The NYSDEC and NYSDOH have reviewed the September 9, 2025 attached revised Knockout Pot Change of Use/Excavation Work Plan (Knockout Pot Project COU/EWP) documentation for work at Sterling Drug Site 1 (Curia) in Rensselaer. The revised 9/9/2025 Knockout Pot Project COU/EWP is hereby approved. Please proceed with implementing this approved project plan, including the notifications to NYSDEC so that onsite inspection of the project can be scheduled.

**RE: Comment Response – Change of Use and Excavation Work Plan  
2025 Knockout Pot Project  
Curia New York, 33 Riverside Avenue, Rensselaer, New York  
Sterling Drug Site #1 NYSDEC Inactive Hazardous Waste Site Number 442009  
CHA Project Number: 075104.001**

On behalf of Curia New York (Curia), please find an enclosed copy of the Revised Change of Use and Excavation Work Plan for the 2025 Knockout Pot Project at the Sterling Drug Site 1 site. The document has been revised in accordance with the comments provided in the New York State Department of Environmental Conservation (NYSDEC) and New York State Department of Health (NYSDOH) comment letter dated August 22, 2025. The NYSDEC/NYSDOH comments and CHA responses are summarized below:

DRAWING NO. 6481 REV 1

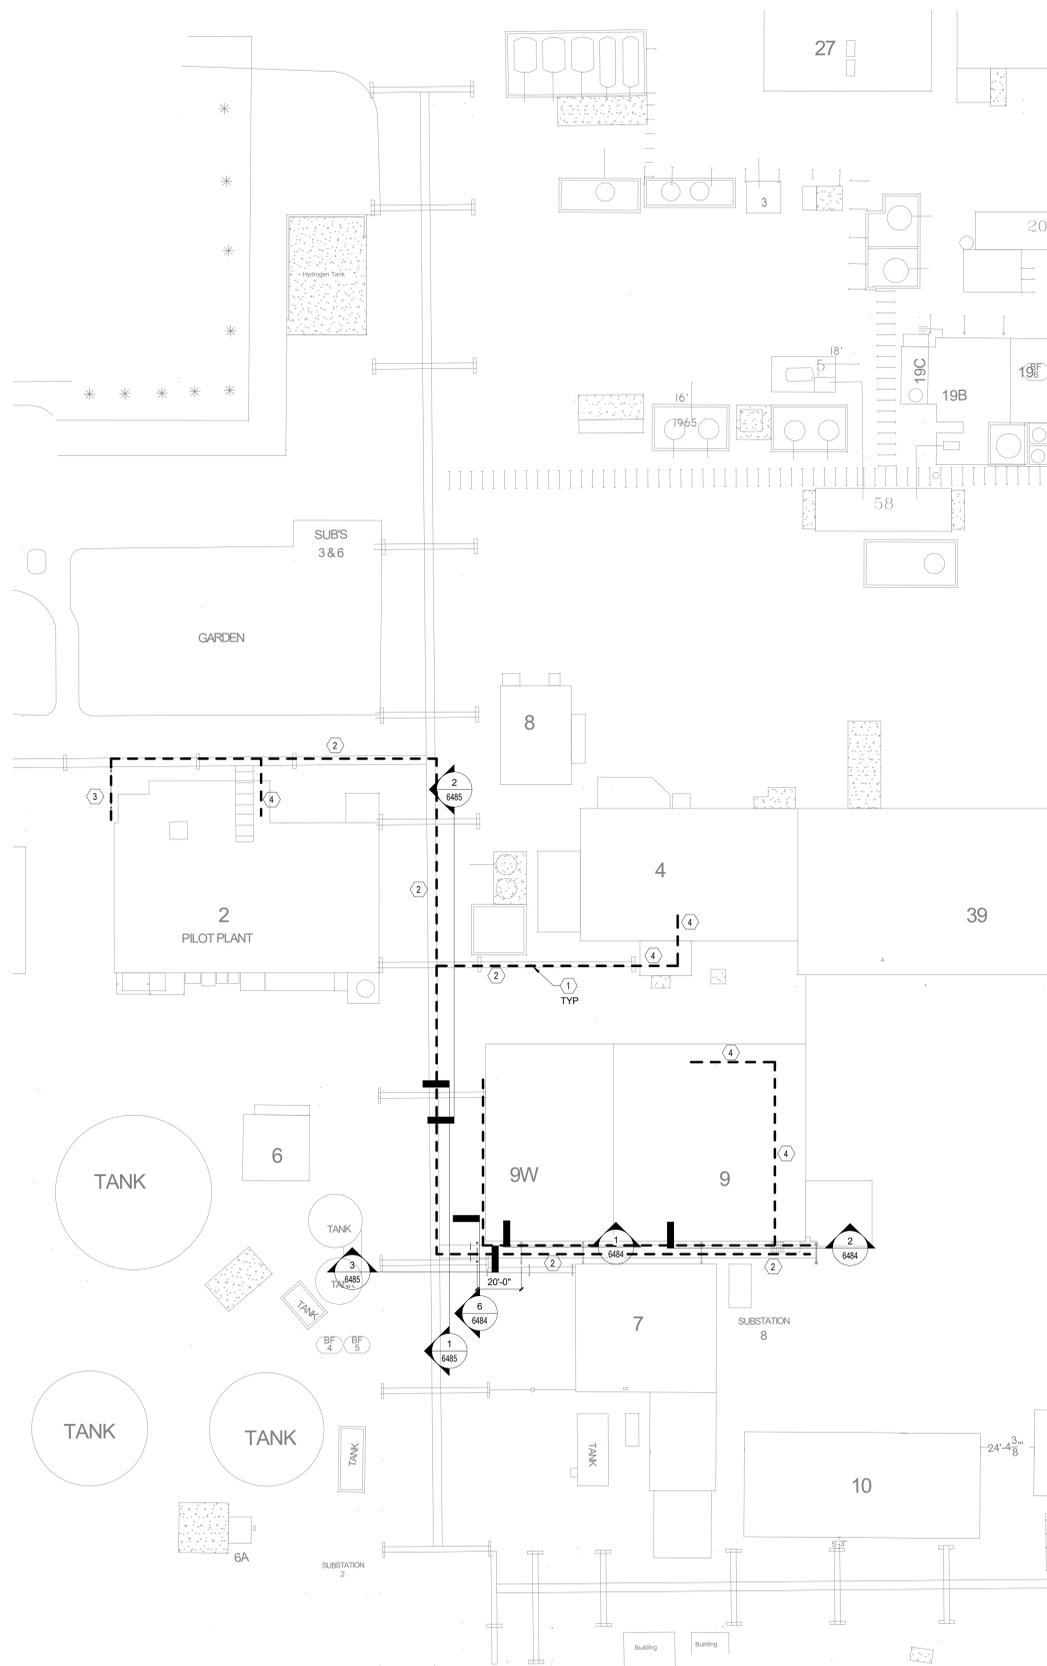
**Comment F:** Construction Drawings #6481 – "General Notes" item F refers to sheet 6482 for "Excavation, Foundation, and Slab on Grade Notes" for NYSDEC-related requirements for soil management and backfill, but the proper reference is sheet #6479.

**Response F:** *The reference on Construction Drawings #6481 has been corrected.*

PROJECT NO. D24AL011	SCALE As indicated	CLIENT NO.
DRAWING NO. 6483	REV 0

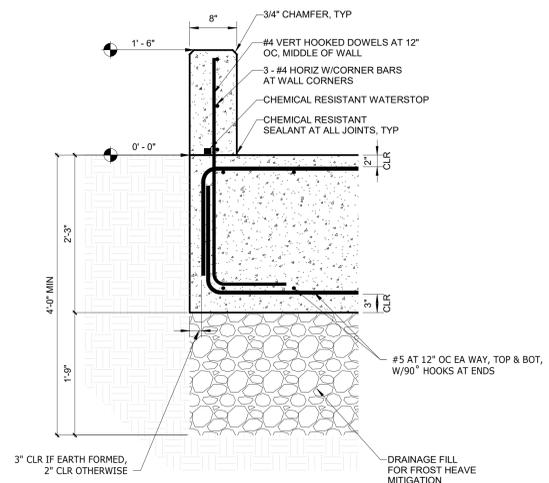
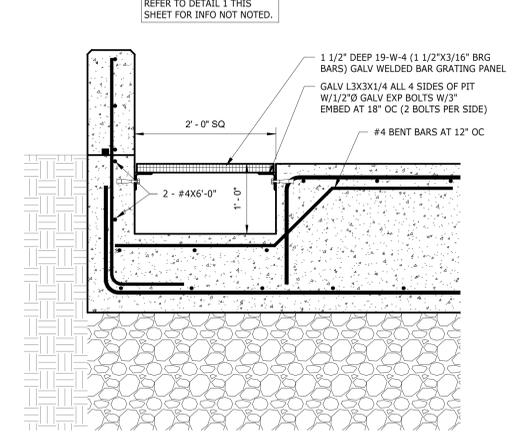
**Comment E:** Cover Letter, 1<sup>st</sup> Paragraph, 7<sup>th</sup> bullet item – Please clarify that the imported stone backfill material or the alternative flowable fill represent the backfill material identified as "Drainage Fill for Frost Heave Mitigation" on the construction drawing #6483.

**Comment G:** Construction Drawings #6483 – "General Notes" item E refers to sheet 6482 for "Excavation, Foundation, and Slab on Grade Notes" for NYSDEC-related requirements for soil management and backfill, but the proper reference is sheet #6479.

**Response E:** *CHA has confirmed that the requested imported stone meets the requirement of the "Drainage Fill for Frost Heave Mitigation" noted on construction drawing #6483.*

**Response G:** *The reference on Construction Drawings #6483 has been corrected.*
